DESCRIPTION OF DIFFERENCES

between ORIGINAL and SIMILARITY

Name of Appliance : 1.9GHz Cordless Telephone System/2.4GHz Bluetooth Transmitter
 SIMILARITY Model No. : KX-TG7841 (Base Unit)
 FCC ID : ACJ96NKX-TG7871

ORIGINAL Model No. : KX-TG7871 (Base Unit)
 FCC ID : ACJ96NKX-TG7871
 Approval Date : under application

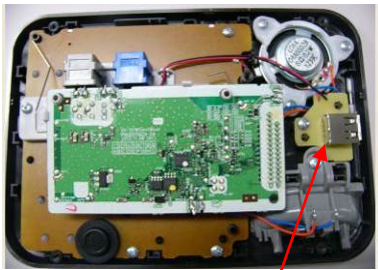
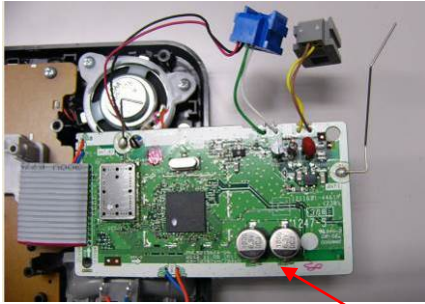
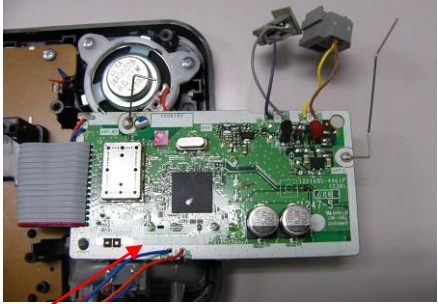
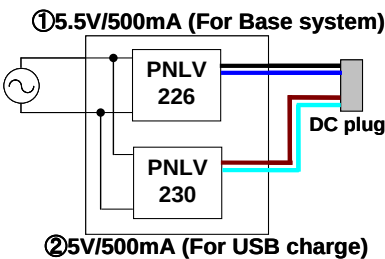
BASIC MODEL KX-TG7871	SIMILAR MODEL KX-TG7841
Appearance		
Top view		
Side view	 Provided with USB connector (DC 5V output only for USB charge)	 Not Provided with USB connector
Rear view	 DC in plug : Modular jack (2 DC voltage input) One is DC5.5V 500mA rated same as PNLV226 adaptor. Another is DC5.0V 500mA rated for USB charge.	 DC in plug : Normal type DC5.5V 500mA rated of PNLV226 adaptor.
Inside Structure	 Provided with USB connector (DC 5V output only for USB charge)	 Not Provided with USB connector

P.C. Board		
AC adaptor	PNLV234 (2 output) 1 DC5.5V 500mA rated (Same as PNLV226) 2 DC5.0V 500mA rated (For USB charge)  <PNLV234 Block Diagram>  ①5.5V/500mA (For Base system) ②5V/500mA (For USB charge)	PNLV226 (1 output) DC5.5V 500mA rated

- (1) The 1.9GHz RF unit and antenna of KX-TG7871 and KX-TG7841 are identical.
- (2) The 2.4 GHz Bluetooth RF Block and antenna of KX-TG7871 and KX-TG7841 are identical.
- (3) AC adaptor PNLV234 use for KX-TG7871 is consisted of containing AC adaptor PNLV226 use for KX-TG7841.
